Response to Submissions

Part 3A Concept Plan Application - MP 10_0237

71-79 Macquarie Street, Sydney

Mixed Use Residential Building

Figure 1 – Integration of proposed Concept Plan envelope

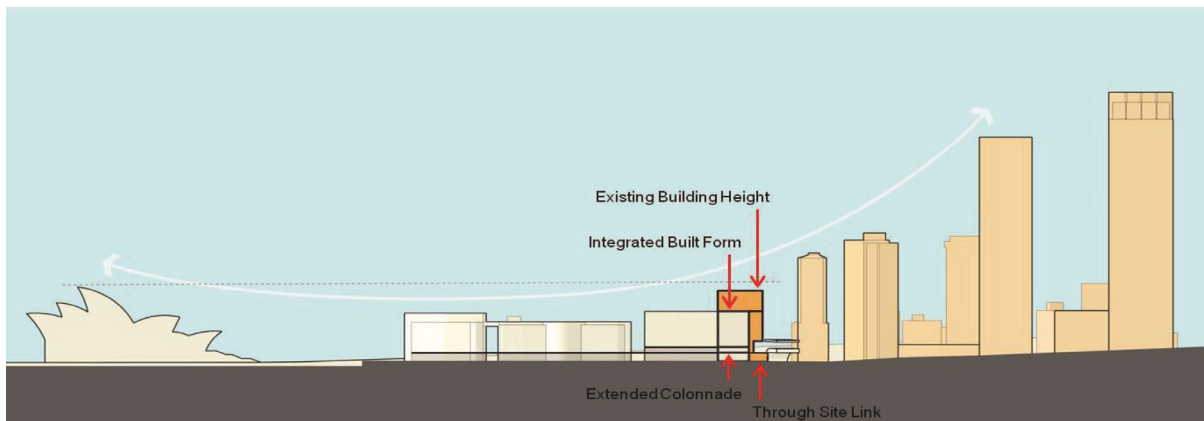
Additional justification is to be provided in relation to the retention of the height and increase in width of the building having regard to current controls applicable to the site, including additional discussion on the height and waiver provisions of the Sydney Local Environmental Plan 2005.

Under Sydney LEP 2005 the height limit of the site is RL46.7, which is the height of Quay Grand building to the north. This equates to approximately 44 metres above the level of the East Circular Quay pedestrian areas. The proposed envelope maintains the height of the existing building, with a parapet height of RL65.37, and a height to the top of the plant room of RL67.23.

It should be noted that the height of the envelope extension to the west (resulting in an increase to the width of the building) does not exceed the height limit for the site as defined in the Sydney LEP 2005.

(b) to provide a transition of building heights between localities and street blocks, and	As identified above and in Section 5.4.1 of the EAR, the proposed built form provides a stepped transition in building scale between the Circular Quay buildings and the CBD. Also refer to Figure 1 below.

Figure 2 – Indicative design solution to maintain daylight access to southern Quay Grand windows

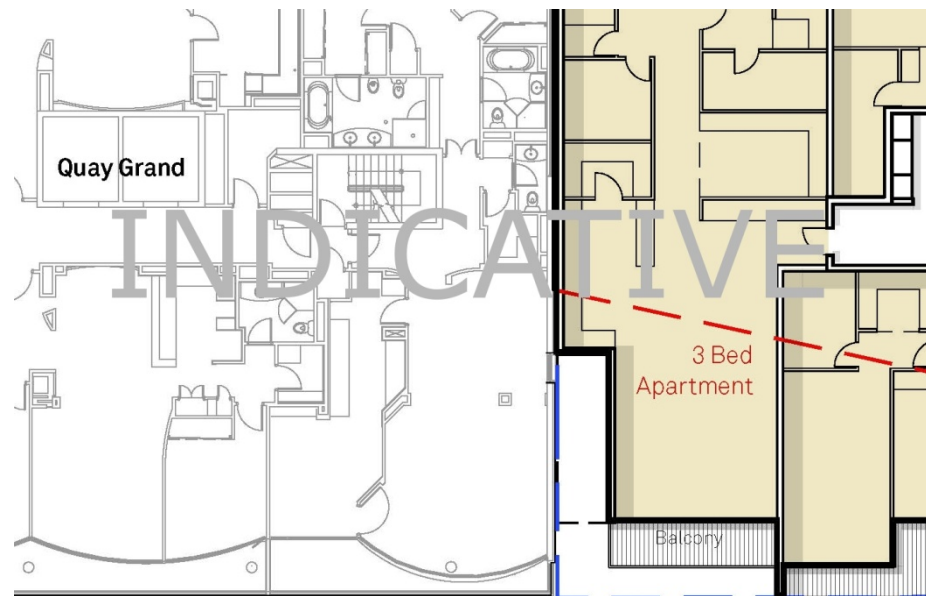
- *retention of the amenity of the south facing obscure glazed windows in the upper floors;*
- *the lower levels of the proposed building having regard to the existing Quay Grand built form; and*
- *the views currently enjoyed from communal facilities on the lower levels.*

Direct sunlight does not currently fall on the southern facade of the Quay Grand building (including its windows) due to its orientation. The obscure glass windows on the southern facade do, however, provide some indirect ambient daylight to the kitchens of the relevant apartments. Due to the obscure glass in these windows, they do not provide any views.

As described in the Environmental Assessment Report (Section 5.4.1), amenity to these windows will be addressed as part of the detailed design and will ensure an appropriate level of amenity is provided in terms of the relationship between the two buildings. In relation to this issue, the Statement of Commitments includes the following:

Indicative plans have been prepared by HASSELL that show a potential design solution that would mitigate impacts on views, privacy, and access to daylight. An extract of these plans are provided in **Figure 2** below, however it should again be noted that these are indicative and may not reflect the design solution proposed as part of the future Development Application (see Statement of Commitment at Section 3.10).
